**EPRI REPORT 3002025288, "ENHANCED RISK-INFORMED CATEGORIZATION
METHODOLOGY FOR PRESSURE BOUNDARY COMPONENTS"**

REQUESTS FOR ADDITIONAL INFORMATION (RAIS)

Figure 1. Categorization process overview [2]

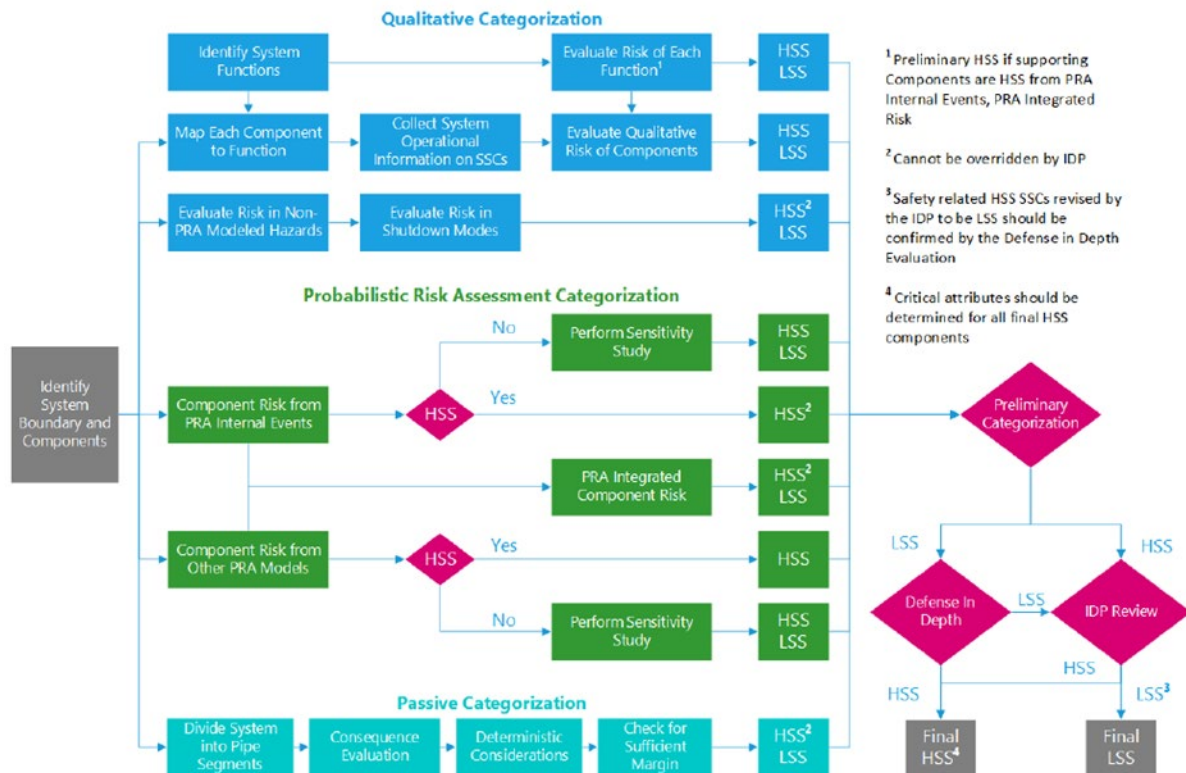
Figure 1 of the TR, “Categorization process overview”, depicts the overall 50.69 categorization process as intended to be implemented, and shows that the passive categorization is performed in parallel to the other aspects of the categorization, such as considerations based on PRA and other qualitative consideration. All these aspects are considered for the preliminary categorization step, per the guidance in Nuclear Energy Institute (NEI) 00-04 Section 7. The guidance in NEI 00-04 Section 7 states that SSCs that support multiple functions should be assigned the highest risk significant of any function that the SSC, or part thereof, supports. Finally, the inputs from the preliminary categorization are provided to the integrated decision-making panel (IDP). Table 1 of the TR states that the IDP cannot change categorization from HSS to LSS for passive components.

- b. As indicated in Figure 1 of the TR, the passive categorization is one aspect of the systematic and integrated categorization process outlined in NEI 00-04. Describe further how the passive categorization will be executed part of the overall integrated categorization process. Describe how the guidance in NEI 00-04 Section 7 for preliminary categorization will be implemented for passive components. How will all aspects of the categorization process be considered for the preliminary categorization of SSCs (both active and passive) that will be provided to the IDP?

As stated in part (a), the passive categorization will continue to follow the applicable guidance outlined in NEI 00-04, with the addition of the prerequisites, the pre-determined set of HSS components (criteria 1-10) and the plant-specific review for risk-significant components (criteria 11). TR 3002025288 does not change active function categorization process.

Exercising the process in TR 3002025288 would allow for pre-determined criteria to be applied upfront to the pressure-retaining function as described in Section 4.2. When using TR 3002025288, the existing integrated categorization process (e.g., NEI 00-04) would remain in place for components with active functions (i.e., no change in the active function or the integrated approach).

As summarized in Figure 1 and Table 1 below, NEI 00-04 provides an integrated and

comprehensive process for risk informed categorizing SSCs that incorporates risk insights from various hazards into a final HSS / LSS determination. The enhanced methodology contained in 3002025288 provides an alternative only to that portion of the process pertaining to pressure boundary categorization (e.g., bottom path of Figure 1 and bottom row of Table 1).

Seismic insights as well as other external hazards and shutdown events are incorporated into the overall risk categorization through several avenues. For seismic, these include the use of a SMA, a seismic PRA or the “tiered approach” defined in EPRI report 3002017583. For fires and other hazards, Licensees will need to follow the guidance contained in NEI 00-04 or describe explicitly in their LAR what alternate approach is being requested.
